## SERVICE INFORMATION NO. SI D4-107

GARMIN – Service Bulletin No. 0823  
ATA-Code: 34-00

**NO.: 0823**

**SUBJECT:** GDU 104X CRS/BARO Knob Interference

**Figure 1**

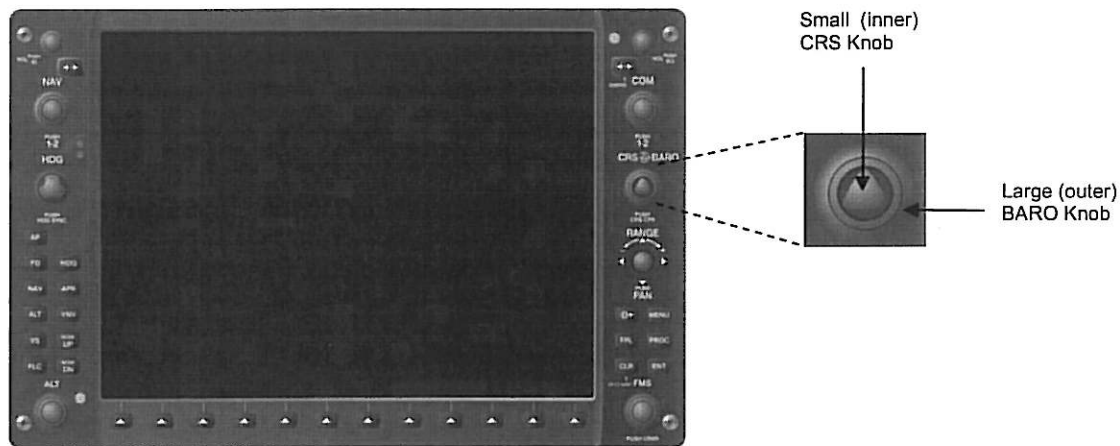
Garmin has identified an issue, whereby the large (outer) BARO knob and the small (inner) CRS knob may interfere with each other.

1. Apply power to the G1000/G900X/G950.
2. Press the CDI softkey on the Primary Flight Display(s) (PFD) to enter VOR mode on the HSI.
3. Rotate the large (outer) BARO knob (refer to Figure 1) a minimum of three complete revolutions in each direction while monitoring the Horizontal Situation Indicator/Digital Course Indicator (refer to Figure 2) on the PFD. If a change in the Horizontal Situation Indicator/Digital Course Indicator is produced while turning the BARO knob proceed to the Modification Instructions.

Figure 2

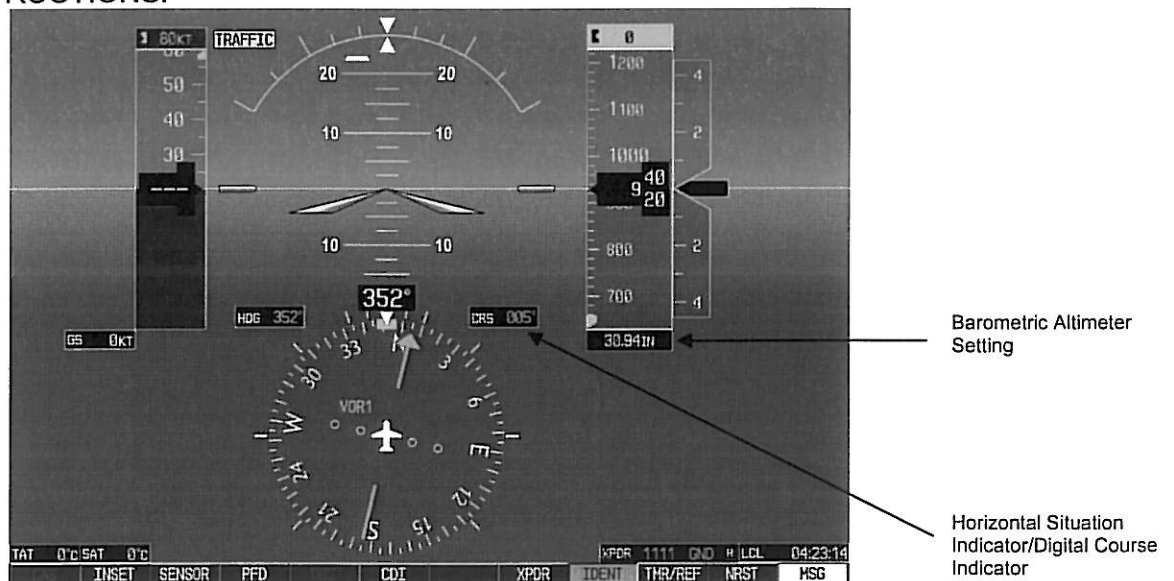
4. Rotate the small (inner) CRS knob (refer to Figure 1) a minimum of three complete revolutions in each direction while monitoring the Barometric Altimeter Setting (refer to Figure 2) on the PFD. If a change in the Barometric Altimeter Setting is produced while turning the CRS knob proceed to the Modification Instructions.
5. Repeat Steps 3 and 4 for each affected GDU.

**Figure 3**

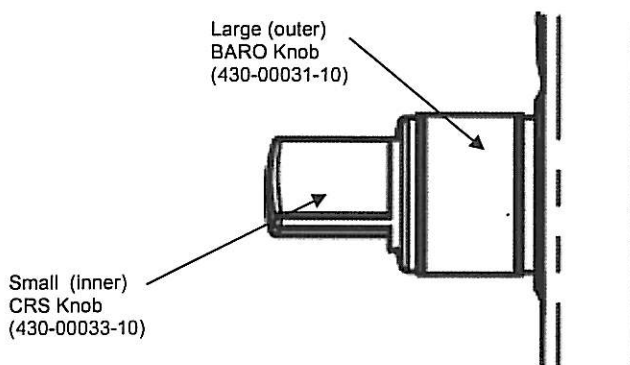
If CRS/BARO Knob interference is confirmed, perform the steps below to replace the CRS/BARO Knob. New knobs can be obtained through a Garmin Service Center or Aircraft OEM under Garmin part number K00-00446-00.

5. Grasp the large (outer) BARO knob (insuring proper orientation) and place it over the shaft.
6. Align the flat side of the knob insert with the flat side of the shaft.
7. Press down firmly to ensure knob is completely seated, refer to Figure 3.
8. Grasp the small (inner) CRS knob (insuring proper orientation) and place it over the shaft.
9. Align the flat side of the knob insert with the flat side of the shaft.
10. Press down firmly to ensure knob is completely seated, refer to Figure 3.
11. Perform the CRS/BARO Knob Interference Test (contained in the TESTING PROCEDURE section) again to confirm there is no interference.
12. Accomplish aircraft logbook entry to return aircraft to service in compliance with this service bulletin.
